Installation of Boom Gates and Signage, Kosciuszko Tourist Park, Sawpit Creek

Development Application Assessment Report
DA 25/4026

November 2025

Figure 2 | Proposed signage and boom gate location plan near the entry to Kosciuszko Tourist Park
(Source: Applicant's documentation, with annotations)

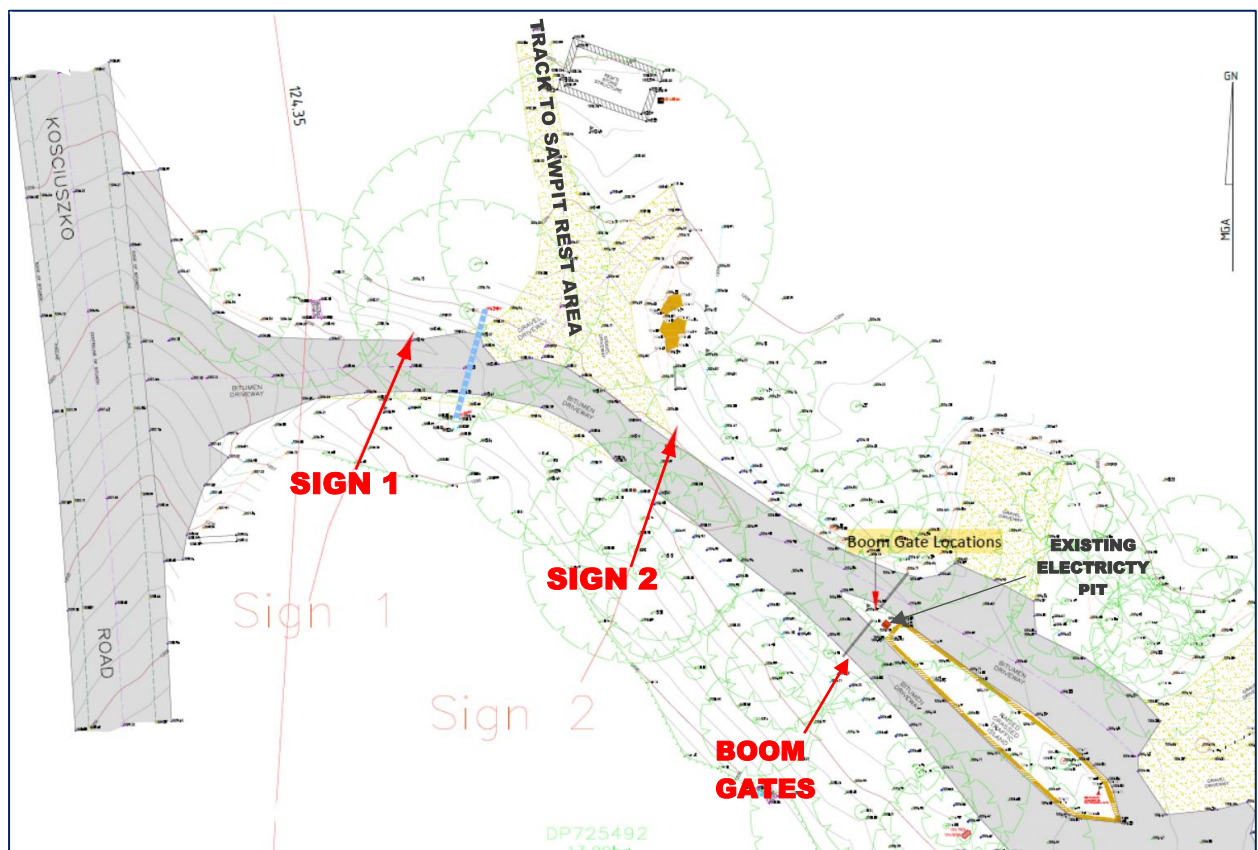
- The indicative content of the signage was not supported by NPWS, who requested that the signage be more consistent with NPWS signage requirements and use standardised and accessible wording and symbology. NPWS requested the Applicant liaise with Parks to ensure that signage is simple and clear for visitors to the Sawpit Creek Picnic Area and to the Kosciuszko Tourist Park. The Applicant then indicated the detail shown on the submitted plans was indicative, and advised that, in relation to the proposed directional signs, they sought only for approval in principle for the signs relating to their location, dimensions and height, and would work with Parks in relation to the content. The Department advised that the content, colour and final size of the signs would be subject to a condition that would require them to consult with the NPWS, and the final signage would be subject to Departmental (Secretary's) approval.

The Applicant was requested to provide further information demonstrating that turning circles could be achieved by vehicles entering the driveway to the KTP, demonstrating vehicles could manoeuvre with safety if the boom gate barriers were in place. For road safety, TfNSW advised that the boom gates were to be positioned and designed to allow vehicles to enter and exit the site in a forward direction without reversing onto Kosciuszko Road. The Applicant worked with TfNSW and the Department to revise the location of the boom gates to ensure they were appropriately located.

Advice was also received from TfNSW in relation to the location and the content of the signage, and the Applicant was requested to revise accordingly.

The Department is providing consent for the location and indicative maximum dimensions of the signs only. The content, colour and final dimensions of the signs will be subject to further development by the Applicant in discussion with the NPWS. While the signage location and configuration appears suitable, in principle, the Department will need to be satisfied in consultation with the NPWS that the final signage is appropriate in the location and consistent with Park requirements. Prior to approval to commence works on the signage, assessment relating to visual amenity will be closely considered having regard to the proposed content and colour palette of the signage and appropriateness relative to the proposed size. The Applicant is aware of the requirement for the signage to be developed further in consultation with the NPWS, and for the final information to be provided to the Department for the written consent of the Secretary or nominee, as will be confirmed as a requirement via a condition of consent.
